**CITY OF MERIDIAN
FINDINGS OF FACT, CONCLUSIONS OF LAW
AND DECISION & ORDER**

Case No(s). H-2022-0079

STAFF REPORT	
COMMUNITY DEVELOPMENT DEPARTMENT

SUBJECT: Modern Craftsman Franklin AZ, CUP, MDA, PP, PS H-2022-0079
(aka Colorado Ridge)

E. Landscape Plan & Fencing Plan (dated: 10/18/2022)

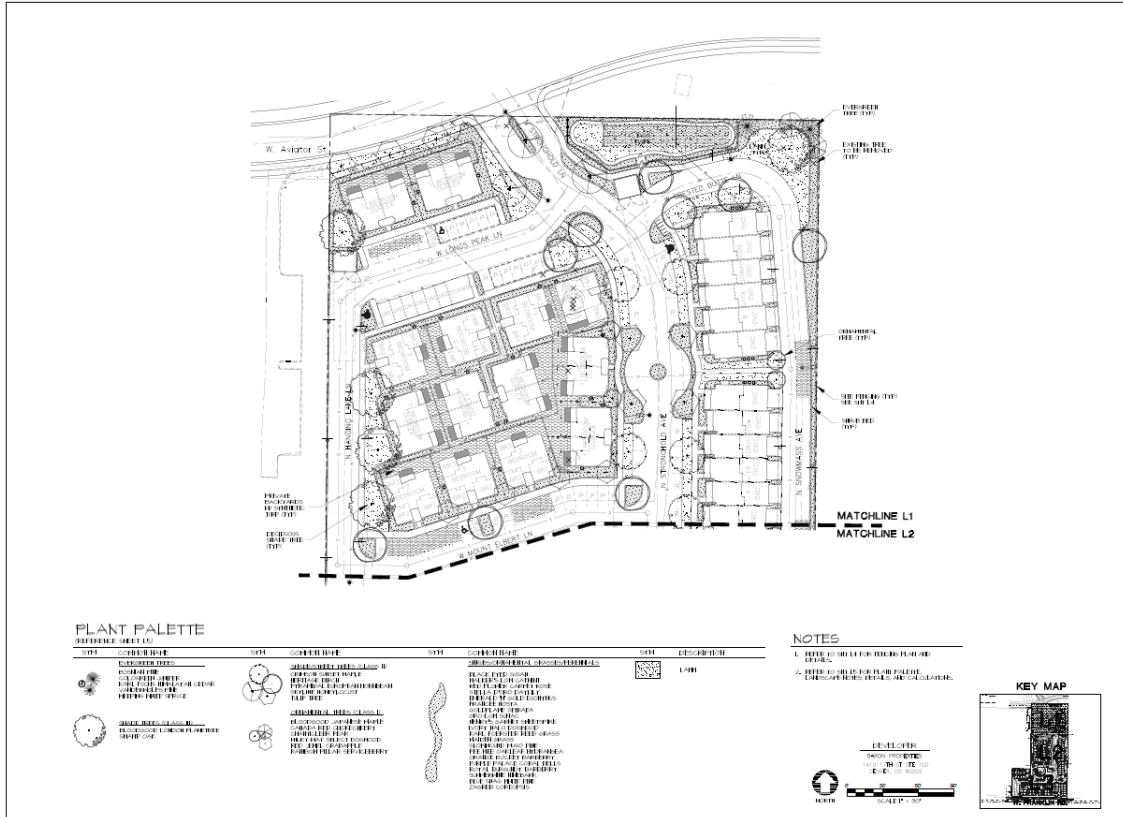
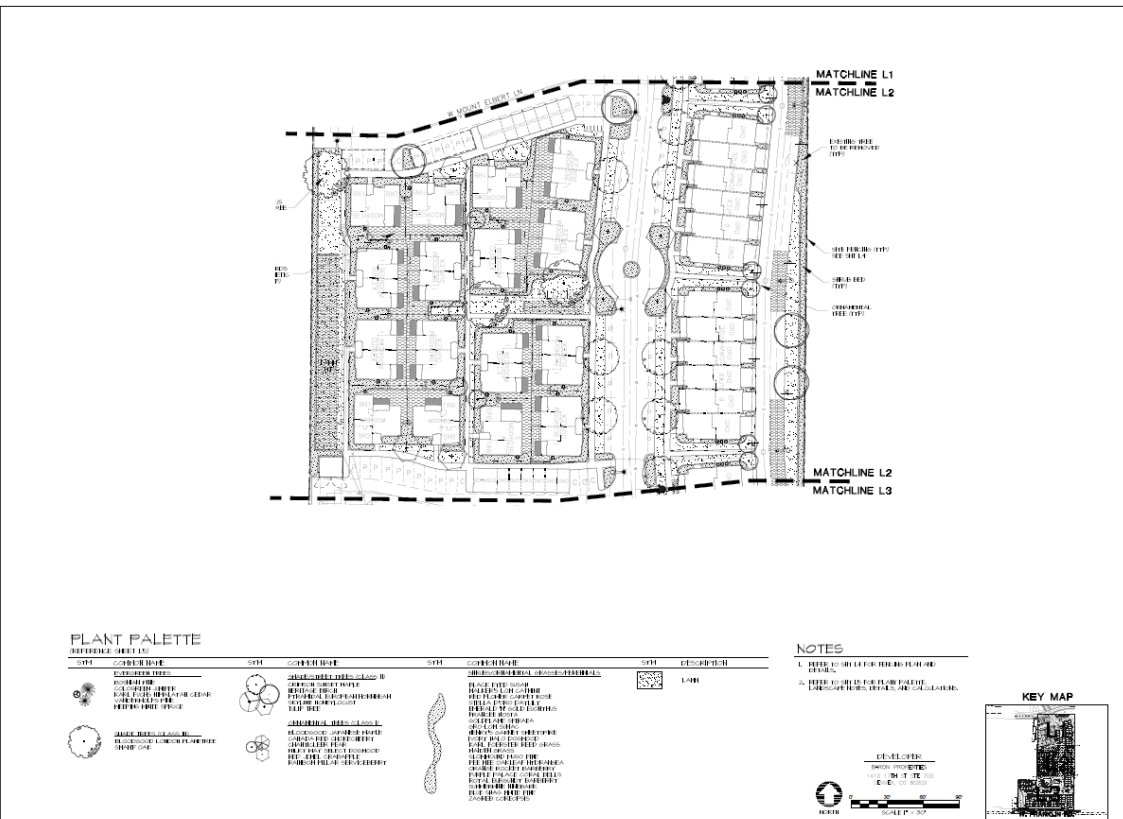
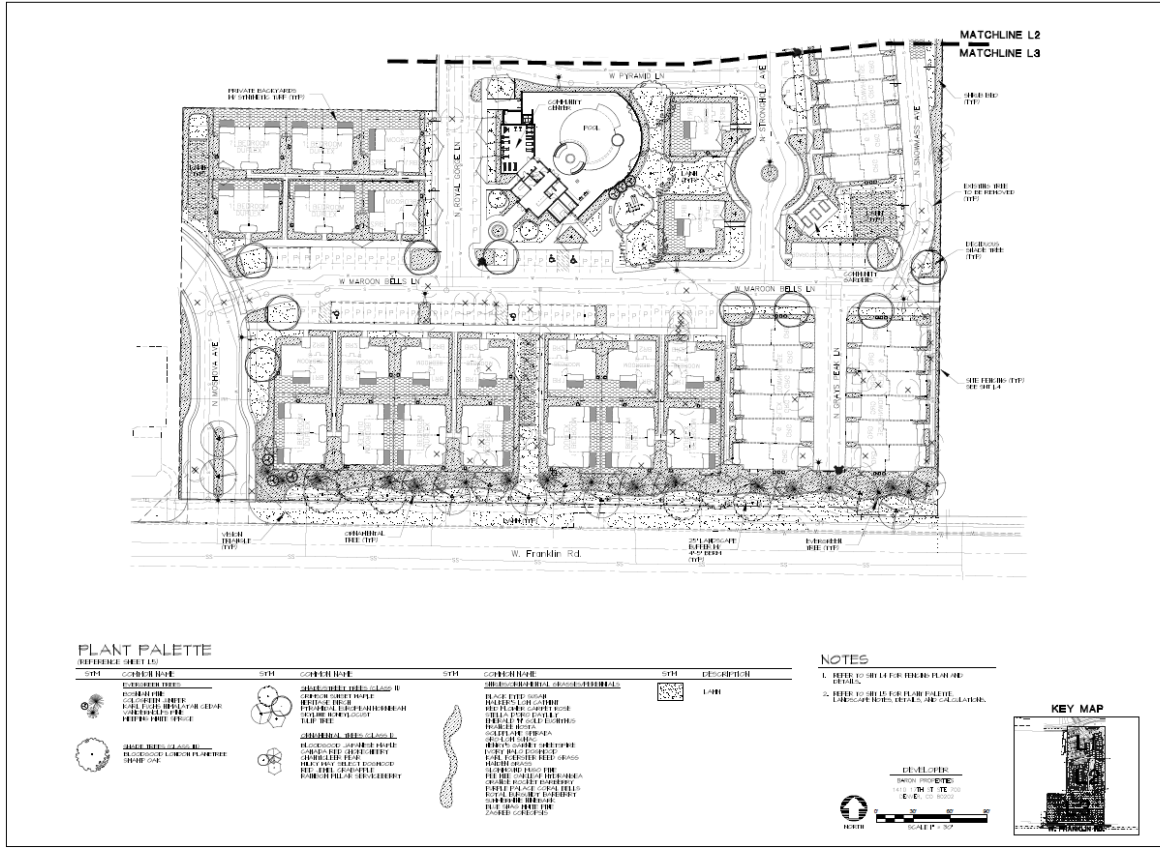
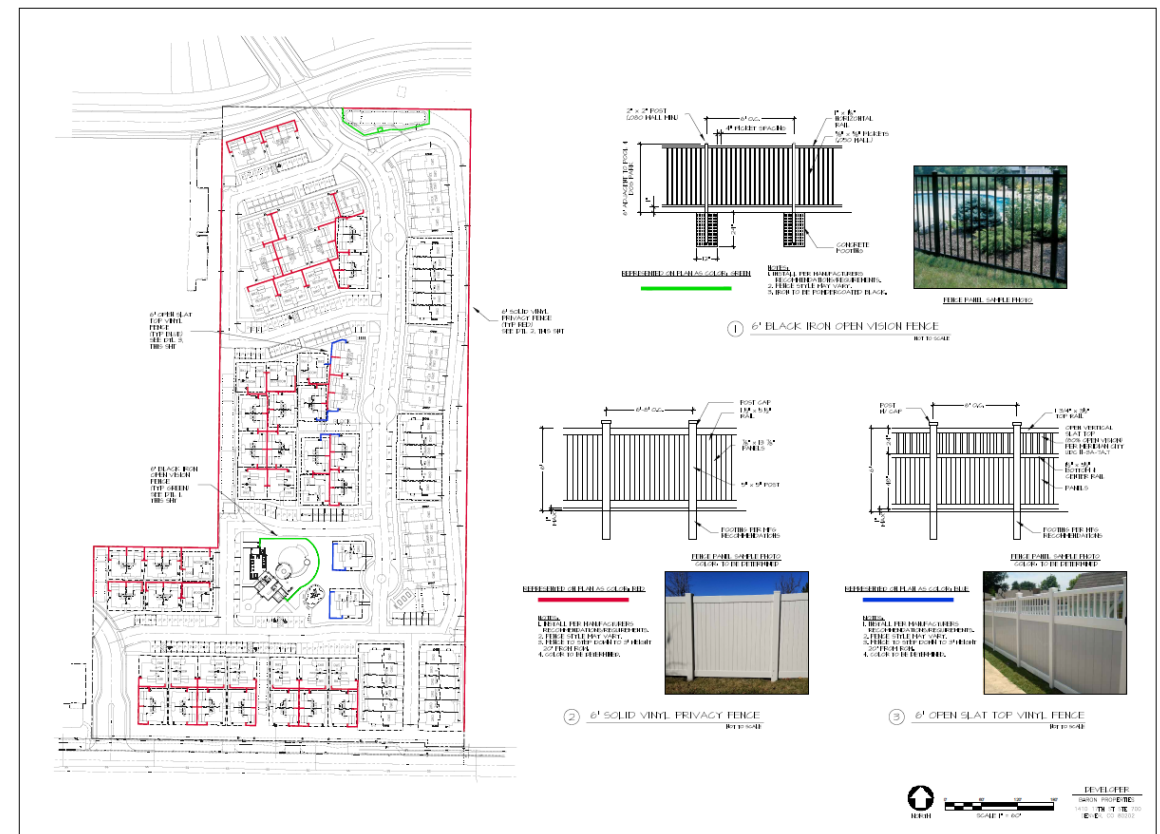
All common open space areas are required to be landscaped with one deciduous shade tree for every 5,000 square feet of area and include a variety of trees, shrubs, lawn or other vegetative groundcover per UDC [11-3G-5B.3](#). **Shrubs should be added to common open space areas and the calculations table on the landscape plan (Sheet L5) should be updated to demonstrate compliance with this standard.**

There are several existing trees on this site that will be removed with development as depicted on the landscape plan. **Mitigation is required to be provided per the standards listed in UDC [11-3B-10C.5](#); calculations demonstrating compliance should be included on the landscape plan submitted with the Certificate of Zoning Compliance and/or final plat application.**

Fencing ([11-3A-7](#)): Fencing is required to comply with the standards listed in UDC [11-3A-7](#). A fencing plan was submitted, included in Section VIII.E, that depicts 6-foot tall solid vinyl privacy fencing along much of the perimeter of the site. A 6-foot tall black iron open vision fencing is proposed around the swimming pool. A 4-foot tall solid vinyl fence with a 2-foot open vertical slat top is proposed in certain locations as depicted on the plan.

- a. Include mitigation calculations on the plan for existing trees that are proposed to be removed in accord with the standards listed in UDC [11-3B-10C.5](#).

- b. Depict landscaping within the 20-foot wide street buffer along W. Aviator St. in accord with the *updated* standards listed in UDC [11-3B-7C](#). An 8-foot wide parkway is required along the collector street planted with Class II trees and a 6-foot wide detached sidewalk as set forth in the TMISAP (Street Section C). Include the linear feet of buffer with the number of required vs. provided trees in the Landscape Calculations table on Sheet L5 that demonstrates compliance with UDC standards.

- d. Change the fencing type along the east boundary of the site adjacent to the Purdam Gulch Drain to 6-foot tall wrought iron in accord with UDC [11-3A-6C.3](#). *Fencing should not encroach within the easement at the northeast corner of the site without a License Agreement with NMID.*

- b. Change the fencing type along the east boundary of the site adjacent to the Purdam Gulch Drain to 6-foot tall black iron open vision fencing in accord with UDC [11-3A-6C.3](#) to deter access to the lateral. If the fence is placed within the easement area, a License Agreement shall be required with NMID.
